PSB#071085
Replace Plastic Disk Slider Stop with Metal Washer
July 10, 1985

TANDEM NOTICE!

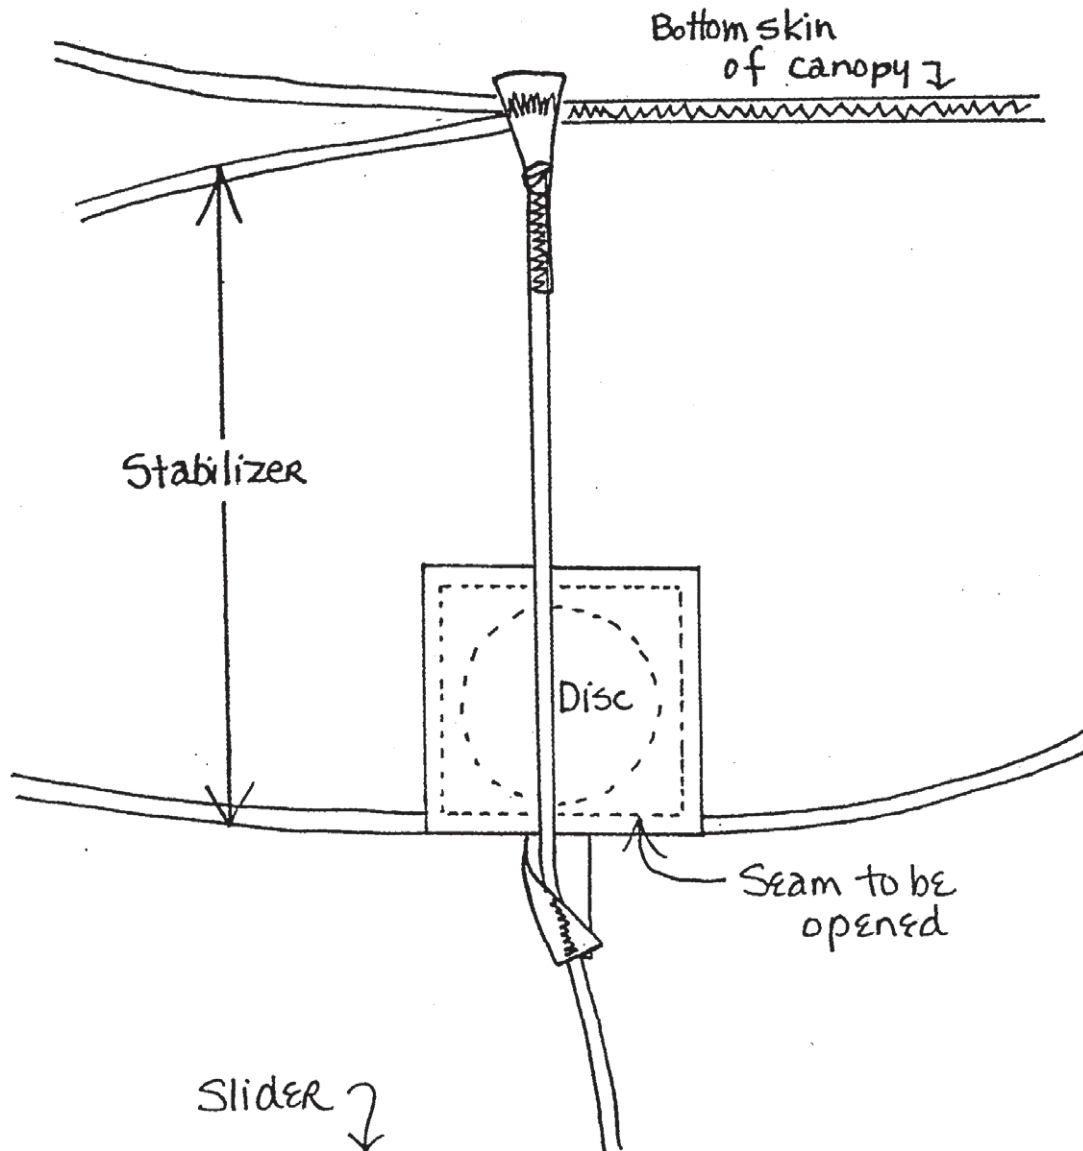
WE HAVE REPORTS OF TWO (POSSIBLY MORE) INSTANCES OF TANDEM SLIDERS PASSING OVER THE SLIDER STOPS SEWN ON THE STABILIZERS.

THE SEAM AT THE BOTTOM OF THE SLIDER STOP POCKETS MUST BE OPENED, THE PLASTIC DISK REMOVED, AND THE METAL WASHER INSERTED. THEN RESEW THE BOTTOM OF THE POCKET. THIS MAY BE HAND TACKED CLOSED IF THERE IS NO MACHINE ACCESS. PLEASE SEE THE ATTACHED PICTURE.

THIS MUST BE DONE ON BOTH THE MAIN AND RESERVE BEFORE YOUR NEXT JUMP.

You were sent four new slider stops (washers) for each Tandem Vector canopy. As you may have noticed, there are six existing slider stops for each canopy at line connection points B, C, and D. All that is required on any canopy is one slider stop per slider grommet.

Therefore, the correct place to put the new stops is at line connection points B & C or B & D. The C & D lines go through the same slider grommet. Because there is a possibility that some of you might have put the four new stops at line connection points C & D, (the only improper combination possible), we decided to issue this follow up letter to be perfectly sure.

Enclosed you will find four more washers. We ask that you replace, at your convenience, the last two remaining stops not replaced previously, preferably the next reserve repack cycle. This will guarantee that the new slider stops are in the right places.
